# TOWN OF NEWBURGH PLANNING BOARD TECHNICAL REVIEW COMMENTS

PROJECT:DONNELLY-LESLIE ROAD SUBDIVISIONPROJECT NO.:20-01PROJECT LOCATION:SECTION 26, BLOCK 6, LOT 25REVIEW DATE:30 JANUARY 2020MEETING DATE:6 JANUARY 2020PROJECT REPRESENTATIVE:ENGINEERING AND SURVEYING PROPERTIES

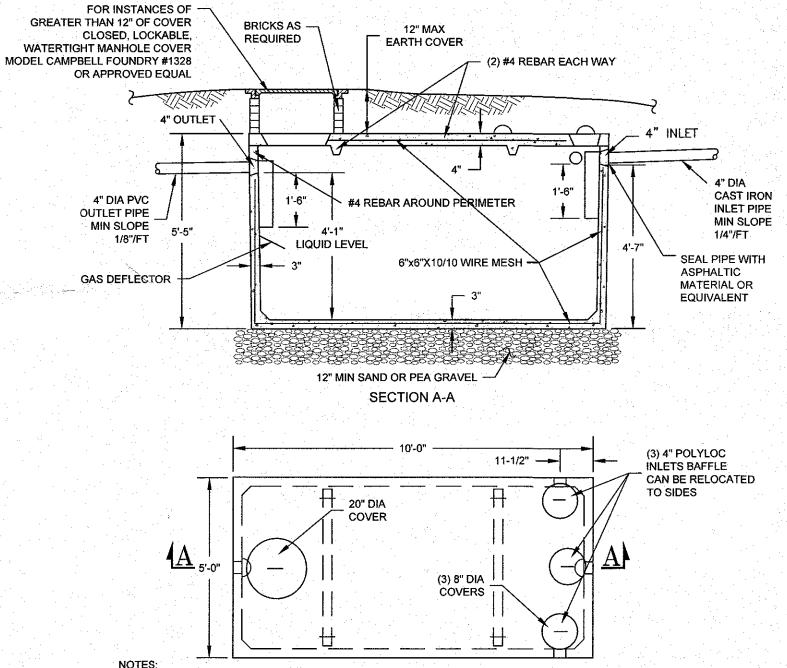
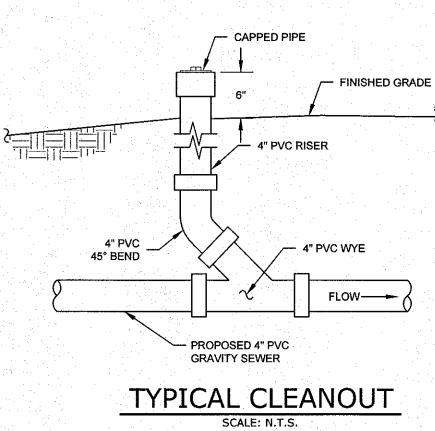
- 5. The septic field detail on Sheet C-2 identifies elgin units in the detail, while the plans identify quick 4 equalizer 36 units for the subsurface sanitary sewer disposal systems. The plan proposes to use a gravel less absorption trench system which is considered a conventional system.

- **11.**The third item in the Septic Design Table identifies 40 mats, Plan Sheet identifies equalizer system for each of the three septic systems.
- **12.** Subdivision plans must bear the stamp of a licensed surveyor.
- **13.** The Lot which identifies a 34 minute percolation rate would require 148 elgin units. Chart identifies 147.
